NSW Planning Assessment Commission Review Report

Maules Creek Coal Project

March 2012

Figure 2: Extent of groundwater depressurisation at the completion of mining³

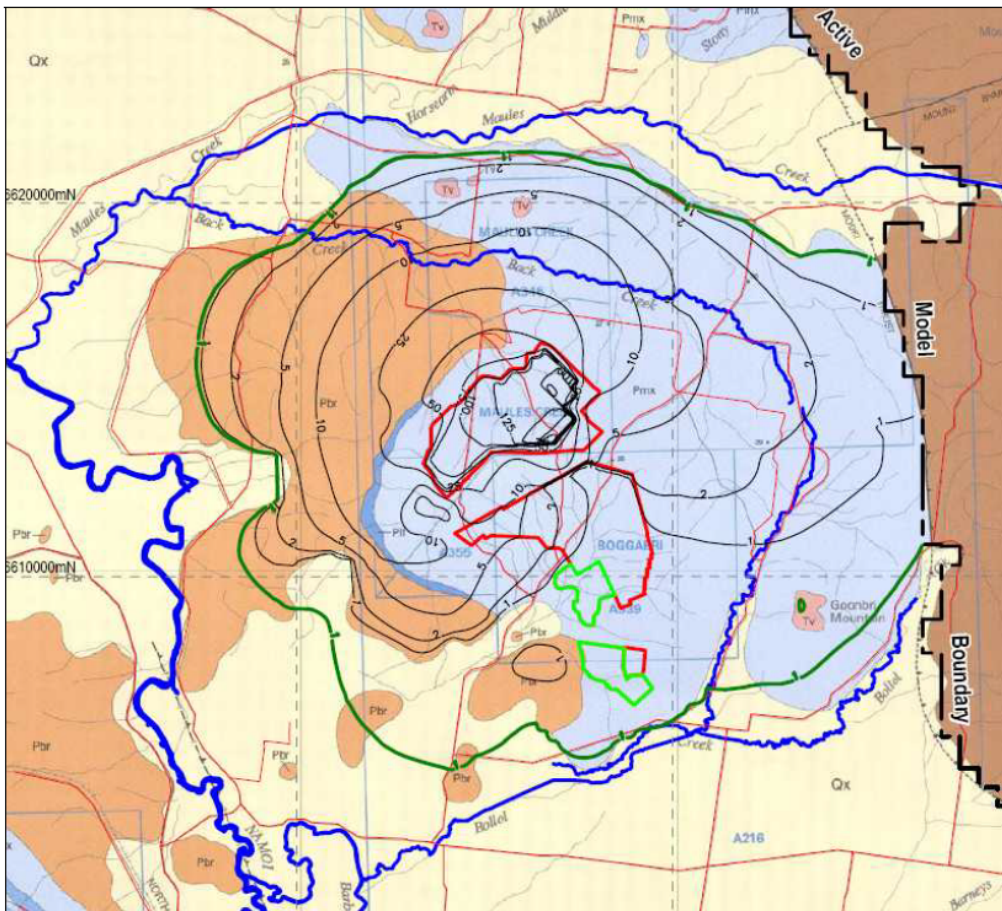
Model output has been provided as a sequence of drawdown contours which show the cumulative effects of Maules Creek and Boggabri Coal operations. Figure 2 below illustrates the predicted impact extent for drawdowns equal to or greater than 1m at various stages of mining. I consider the use of a minimum impact level of 1m to be appropriate. Often the 2m drawdown impact zone is regarded as appropriate based upon typical borehole construction and behavior of bore water levels over time.

Depressurisation leads to a reduction in sub-surface groundwater flows from the Permian strata, to the alluvial lands to the south-west and north. The calculated reduction attributed to the Maules Creek

Figure 3: Interpreted pit shell spill point¹⁰- Year 21 mine layout before reshaping

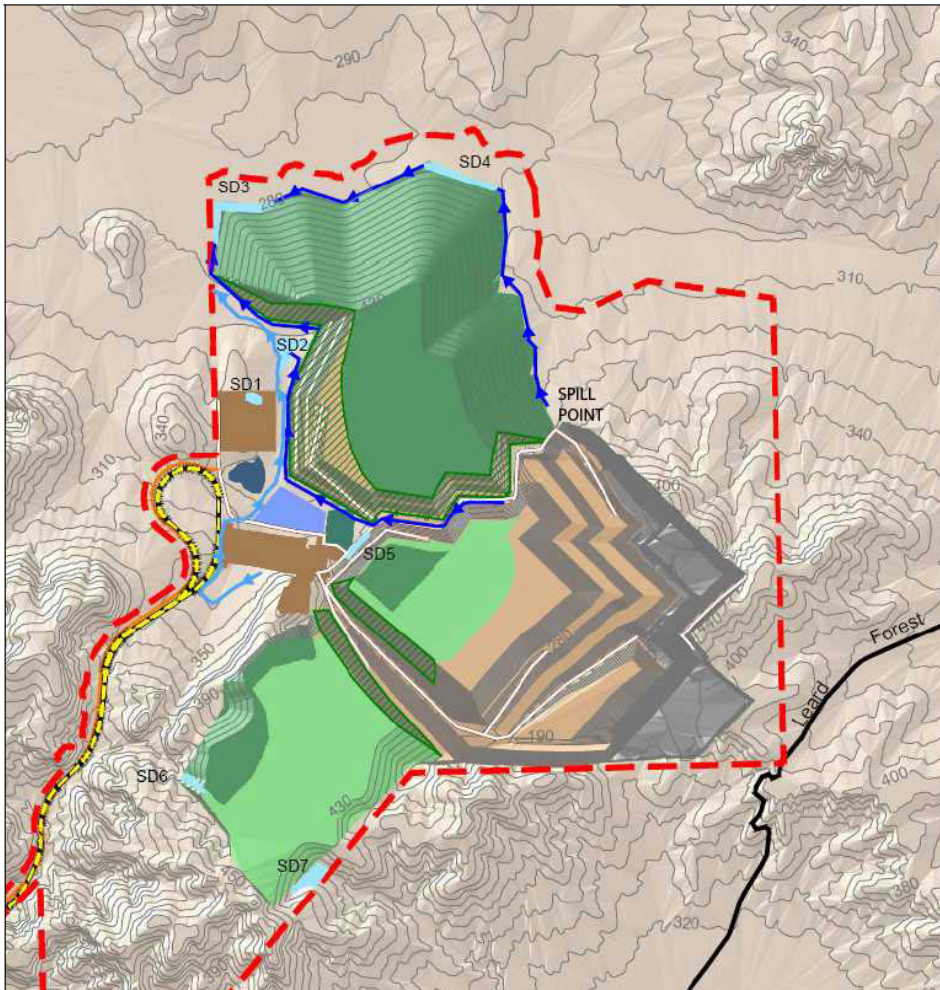
Results of similar tests conducted on potential rejects materials indicate that most of the samples tested also have a low risk of acid generation and a high factor of safety. The few samples that exhibit some potential (Braymont, Hermdale and Onavale seams) may however, constitute a significant percentage of the rejects materials at different times during the mining process. They are also likely to generate a more saline leachate when compared to overburden. These materials are proposed to be located deep in the pit shell⁹ and presumably intended to be placed well below the long term recovered water table. Accordingly they are reported as unlikely to represent a risk to the regional shallow groundwater systems (beyond the pit shell) post closure.

If closure Option 1 is adopted, the evolution of a pit lake will generate increased salinity in the void waters to a long term electrical conductivity (EC) value probably in excess of 15000 uS/cm (9000 mg/l). Containment of saline waters and mitigation of any adverse impacts regionally, will rely entirely upon the long term maintenance of an hydraulic sink.

If Option 2 is modified to promote discharge to the spill point then the characteristics of the discharge are predicted to be pH neutral, slightly alkaline and relatively low salinity with ionic species dominated by sodium bicarbonate, chloride and sulphate¹¹. The EC value to be likely to be lower than 250 uS/cm. I consider this EC/salinity to reflect relatively benign conditions and therefore encourage this approach to pit closure.

Figure 4: Cumulative extent of groundwater depressurisation at the completion of mining

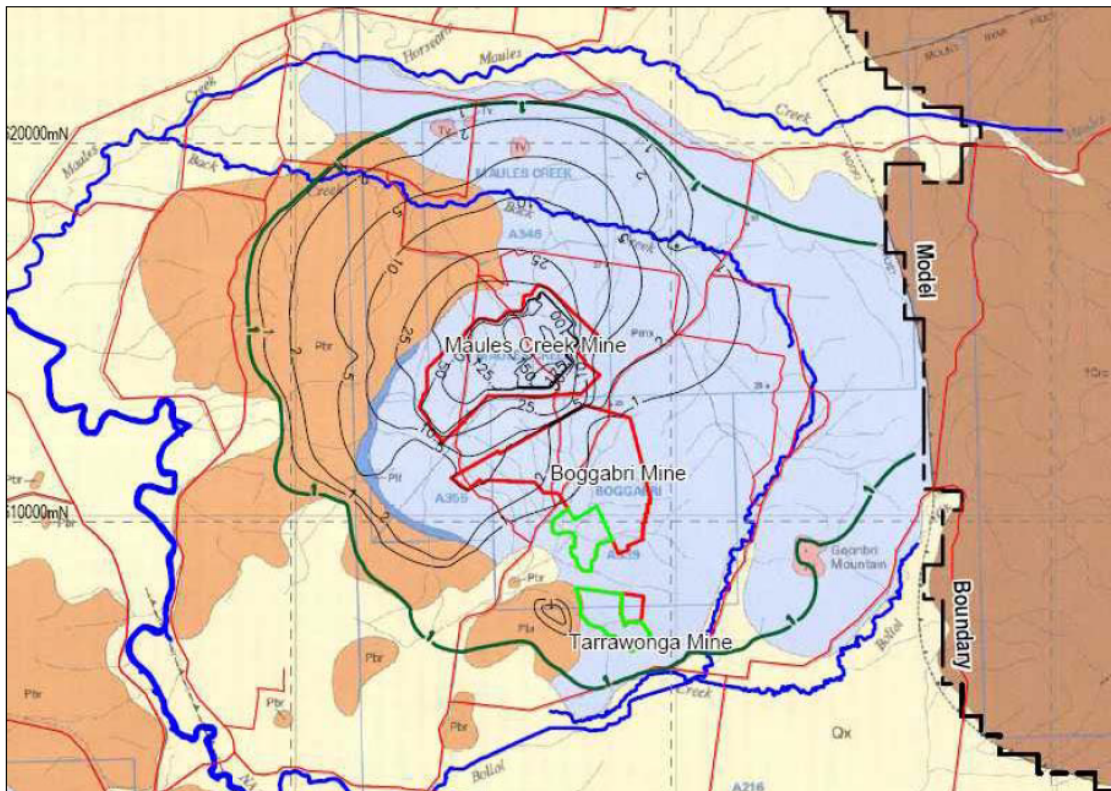
Impact plots have been prepared by AGE for mining year 21. Figure 4 shows the predicted drawdowns specifically calculated for Maules Creek project and excluding Boggabri and Tarrawonga coal projects. That is, the cumulative drawdown impacts from all mines are not represented. Only the 1 m drawdown contour is presented for cumulative assessment purposes¹². This contour is shown on Figure 4 as the green 1m contour.
